### RECOMMENDATION REPORT

#### South Valley Area Planning Commission

**Case No.:** APCSV-2018-2184-ZC-BL  
**CEQA No.:** ENV-2018-2185-MND  
**Incidental Cases:** N/A  
**Related Cases:** N/A  
**Council No.:** 6 – Padilla  
**Plan Area:** Reseda-West Van Nuys  
**Geographic Overlay:** N/A  
**Certified NC:** Lake Balboa  
**GPLU:** Low Medium II Residential  
**Zone:** R1-1  
**Applicant:** Shahe K. Boyadjian and  
Maral H. Boyadjian  
**Representative:** Mailian and Associates

**PROJECT LOCATION:** 17534 - 17540 W. Sherman Way

**G-101**

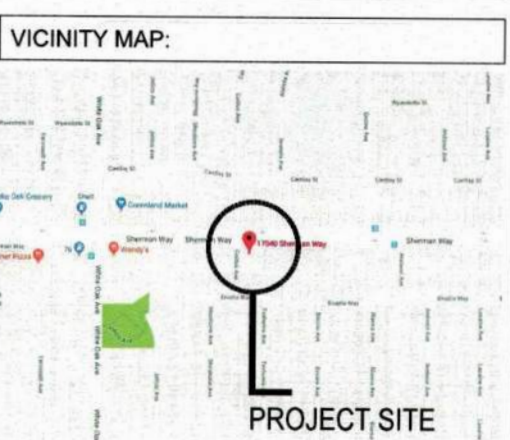
The applicant is required to provide a minimum total of 356 square feet of landscaping for the common open space areas (25 percent of 1,425). The applicant's plans ("**Exhibit A**" Sheet G-

101) show 2,690 square feet of landscaping on the ground floor. An additional 394 square feet of landscaping is provided on the second floor within the common open space area, for a total of 3,084 square feet of landscaping. The project design also includes balconies adjoining each unit.

SHEET NUMBER:  
**A-112**

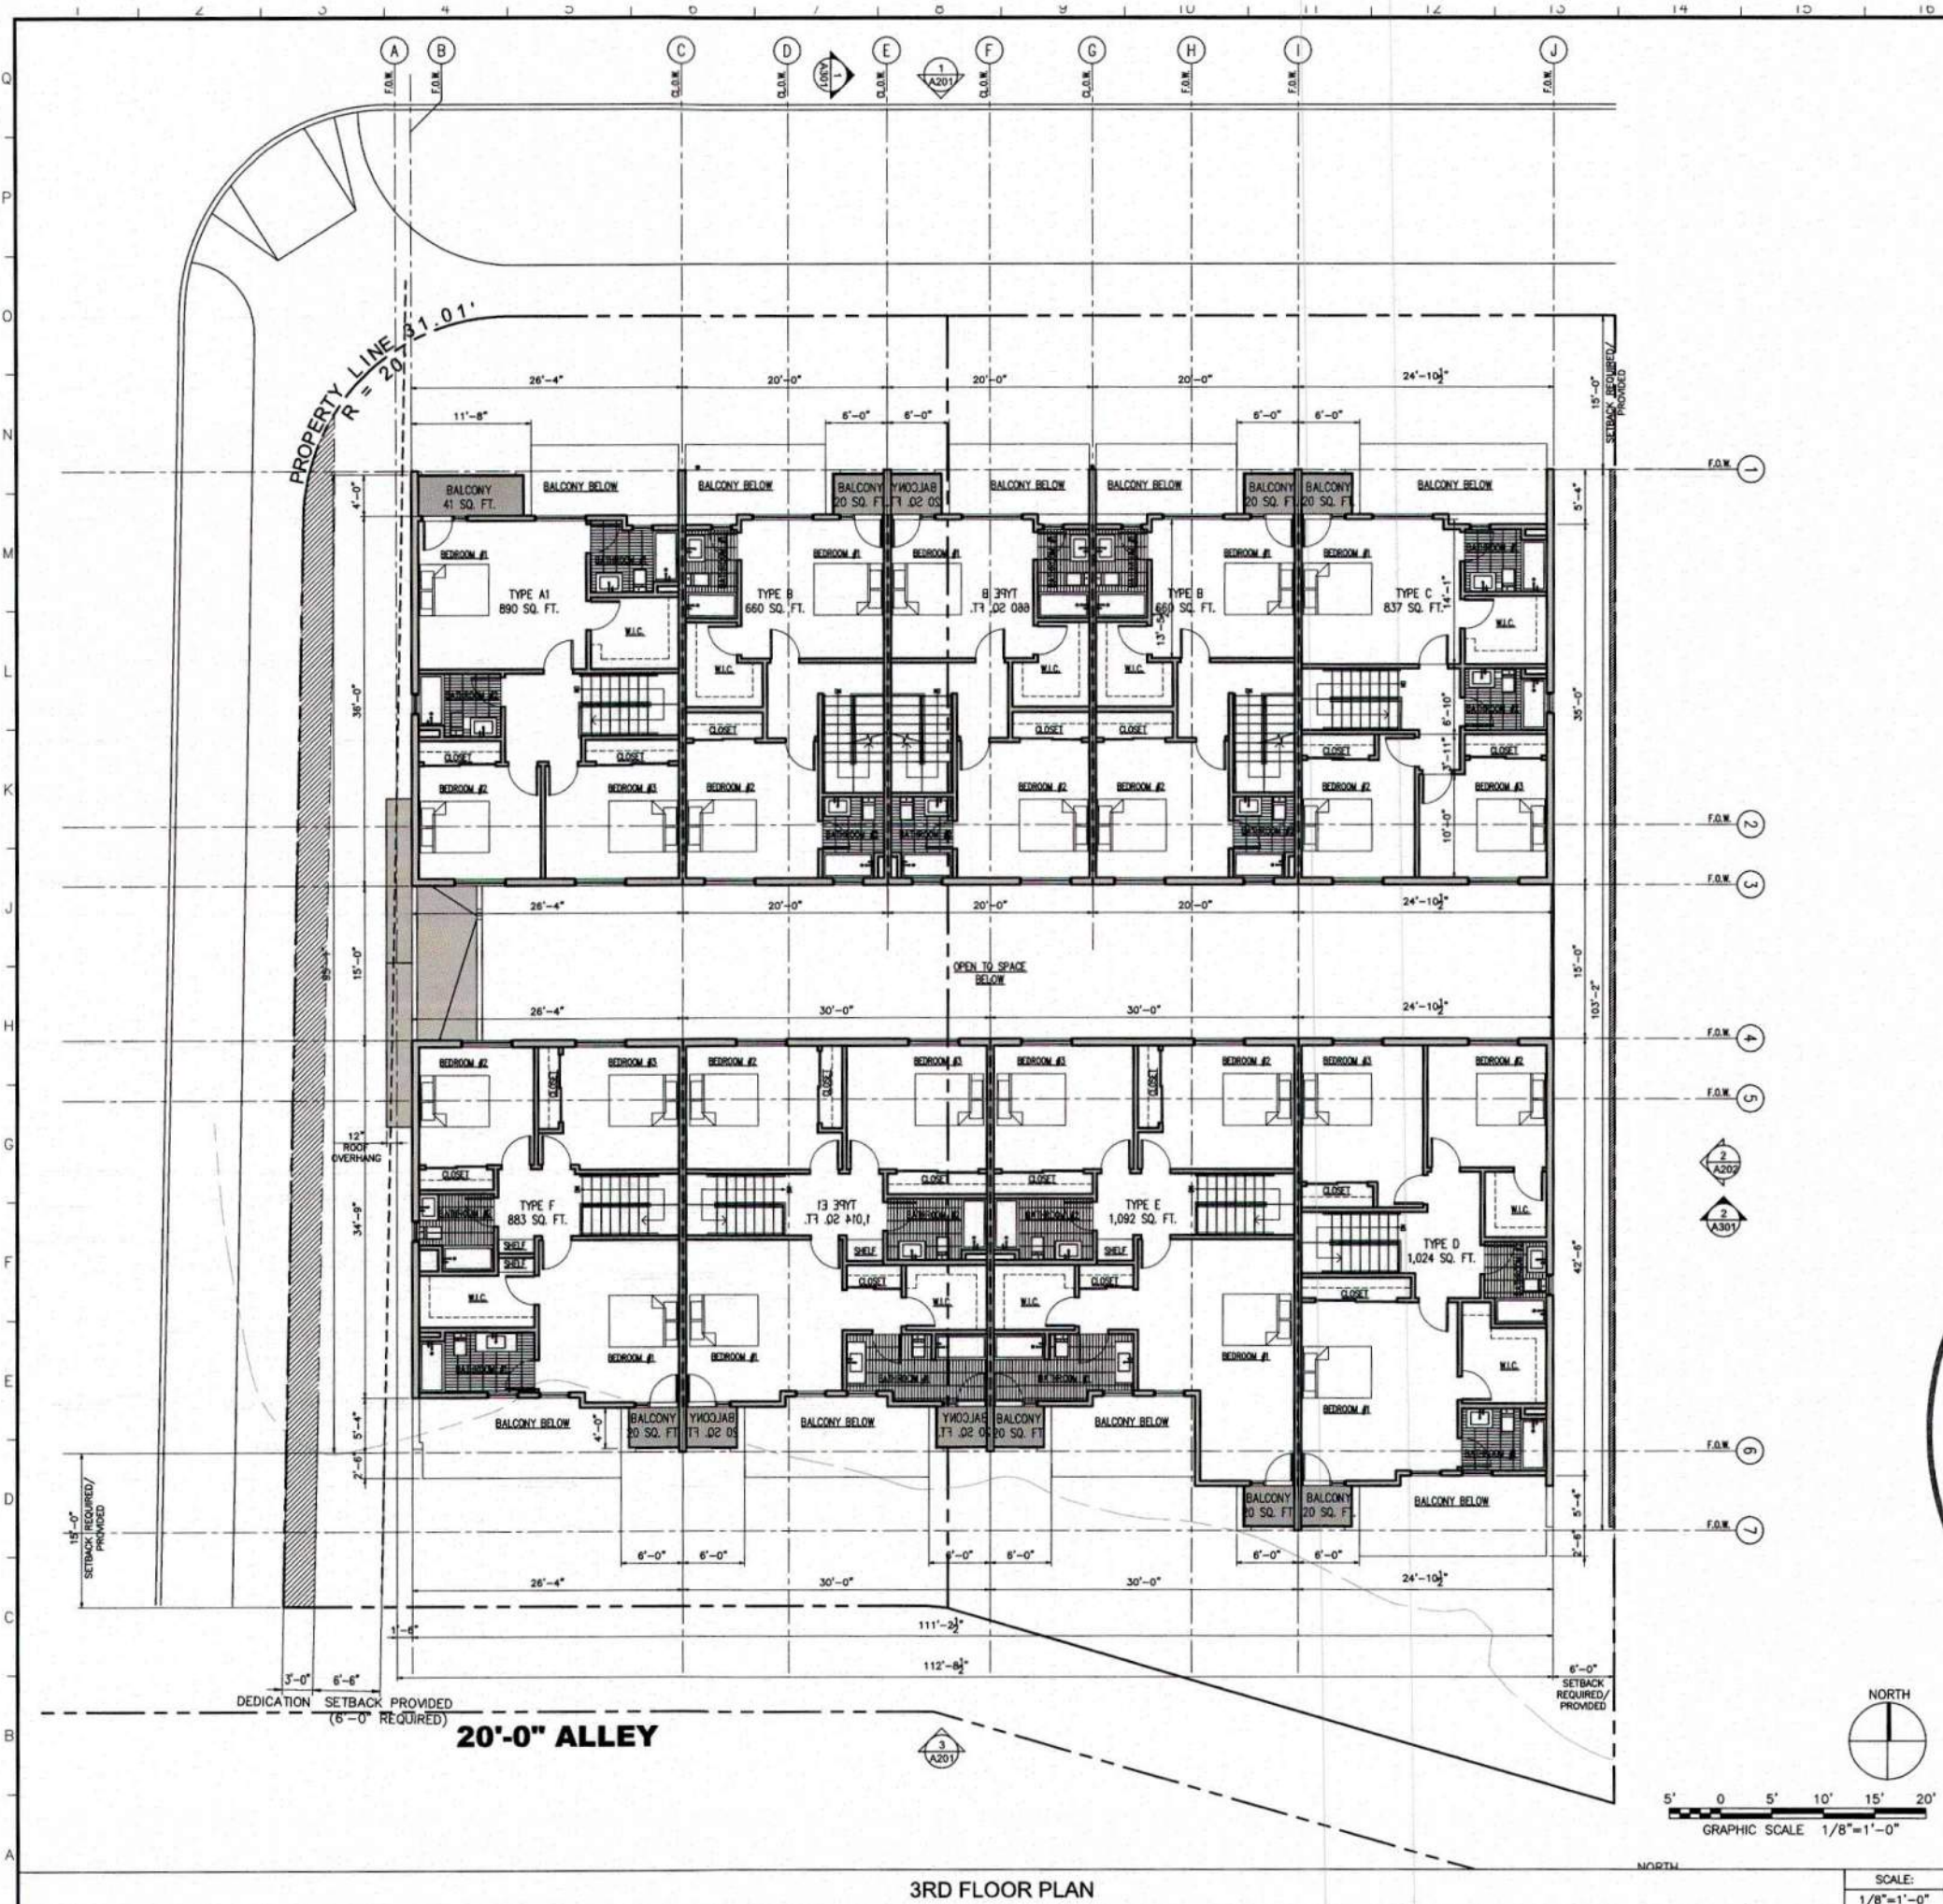
PVP COMMENTS	APPLICANT'S RESPONSE
<ul style="list-style-type: none"> <li>Walling-off of project from street behind raised planters detracts from overall appearance.</li> </ul>	<p>The walling of the project from the street with raised planters was a Planning Department suggestion from a previous meeting. The planters create a buffer between the large scale of Sherman Way and the private outdoor spaces in front of each unit.</p>
<ul style="list-style-type: none"> <li>Designer seems overly attached to symmetry (e.g., when one shared, vehicular ingress/egress would serve as well as doubling vehicular ingress/egress and a single driveway would free up space for more landscaping and improved entry sequence to alley-facing units.</li> </ul>	<p>The driveways (whether one or two) will take up approximately the same space and will not allow for more landscape.</p>
<p>Climate Adapted Design:</p>	
<ul style="list-style-type: none"> <li>Neither courtyard nor patios are laid out or programmed in a convincing way to suggest that these will be highly used or usable as shared open space.</li> </ul>	<p>We have included built in benches with the planters at the courtyard, see Sheet A-112.</p>

<ul style="list-style-type: none"> <li>Patios at Sherman Way should be separated into individual spaces; as currently shown will create areas hidden from street within a space over which no one has a sense of ownership.</li> </ul>	<p>The owner did not want to add walls between the patios. We have individual walkways and entrances from Sherman way which will give ownership to the space to each unit.</p>
<ul style="list-style-type: none"> <li>LID should be approached in more of a holistic way by employing direct (gravity-fed) infiltration from gutters into planting areas vs. first being held in rain tanks to improve patios on Sherman Way and address the reality that tanks will be empty during majority of the year in which all non-native or Mediterranean species will experience the greatest irrigation demand.</li> </ul>	<p>LID has specific requirements from the Bureau of Sanitation.</p>
<ul style="list-style-type: none"> <li>Consider taking advantage of maximum architectural projections into front/rear setbacks to make balconies a more useful connection with the outdoors plus promote eyes on the street.</li> </ul>	<p>Please see Sheet A-112.</p>

- a. Landscaping as shown on the applicant's plans, "**Exhibit A**" Sheet A-112, shall be corrected to be consistent with "**Exhibit A**" Sheet G-101. Specifically, the applicant shall show 2,690 square feet of landscaping on the ground floor. An additional 394 square feet of landscaping shall be shown on the second floor within the common open space area, for a total of 3,084 square feet of landscaping.
